### **3.4 TOTAL DISSOLVED GAS (TDG) MONITORING – 2001: RESPONSE OF DISSOLVED GAS SATURATION DOWNSTREAM OF THE SWIFT NO. 1 PROJECT TO REDUCED TURBINE AIR INFLOW (WAQ 4)**

### 3.4.8 Comments and Responses on Draft Report

This section presents stakeholder comments provided on the draft report, followed by the Licensees' responses. The final column presents any follow-up comment offered by the stakeholder and in some cases, in italics, a response from the Licensees.

**Figure 3.4-3. Percent saturation (n = 366) relative to project (Units 1 and 2) discharge at Yale powerhouse (with air regulation valve modified) in summer 1997 and 1998.**

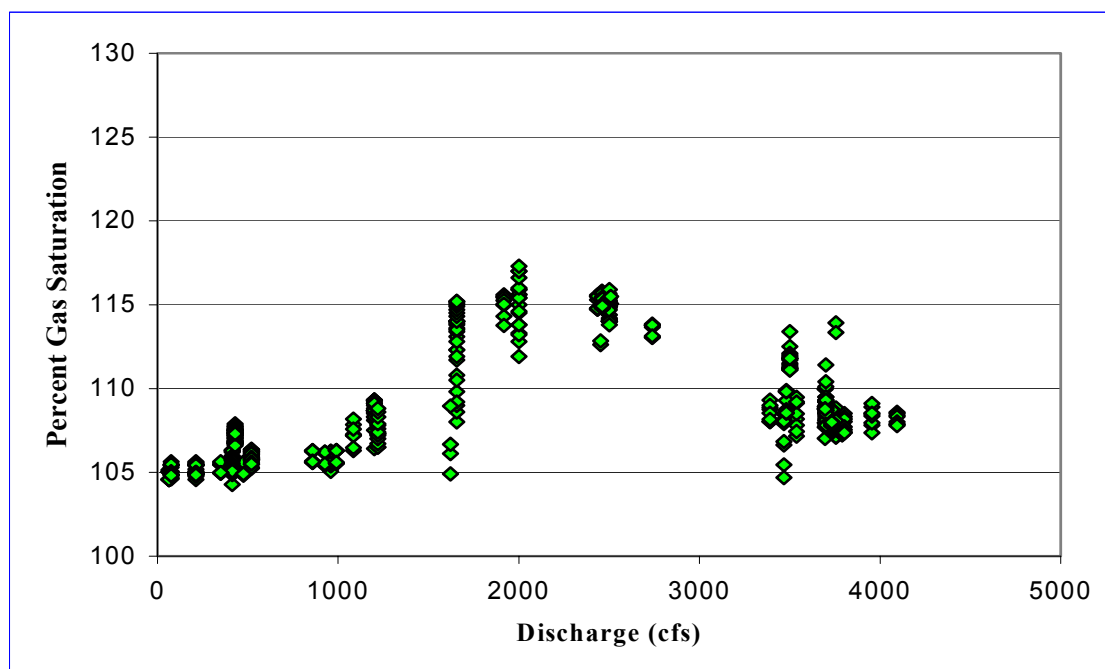
J. Sampson, Technical Advisor to the Conservation Groups	1	WAQ 04-7 para 1	“With the air vent capped at lower generation levels, TDG saturation in the tailwaters is less than when compared to Figure 3.4-1.”	This statement is incomplete. The following should be added after this sentence:  “Nevertheless, between discharges of 1500 and 3000 cfs, TDG in the Yale tailrace still violates water quality standards.”	This statement is correct based on Figure 3.4.4 which shows that TDG levels remain below the state standard of 110 % throughout the generation range of each turbine when the air vent is restricted 100 % (capped). However, as stated in the report, it is not possible to cap the air vent at all generation levels due to physical constraints such as cavitation and pressure differentials within the turbine and draft tube. Both conditions are destructive to the units and would result in premature wear or damage.

**Figure 3.4-5. Percent gas saturation and generation while the outside air vent is 100 percent capped at the Swift No. 1 tailrace (Unit No. 11) in October 2001.**

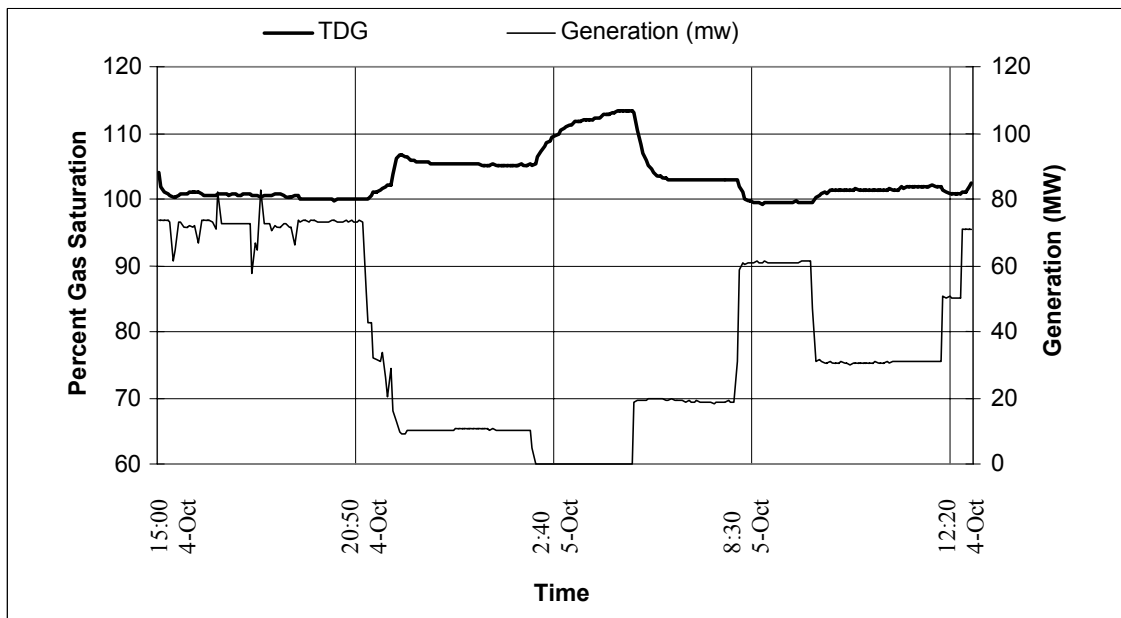
J. Sampson, Technical Advisor to the	1	WAQ 04-7 para 3	“Figures 3.4-5 and 3.4-6 display the time	Figure 3.4-5 indicates that at zero generation (October 5 <sup>th</sup> , 2:40), TDG exceeds the water quality criterion of	The cause as to why the tailrace remains over-saturated after the units are

<b>Commenter</b>	<b>Volume</b>	<b>Page/ Paragraph</b>	<b>Statement</b>	<b>Comment</b>	<b>Response</b>	<b>Response to Responses</b>
Conservation Groups			series response of TDG to changes in generation.”	110% supersaturation. This should be explained in the text following this statement.	taken off-line remains unknown. An explanation would be speculative. However, some things are known that may contribute to this prolonged saturation period and those will be added to the final report.
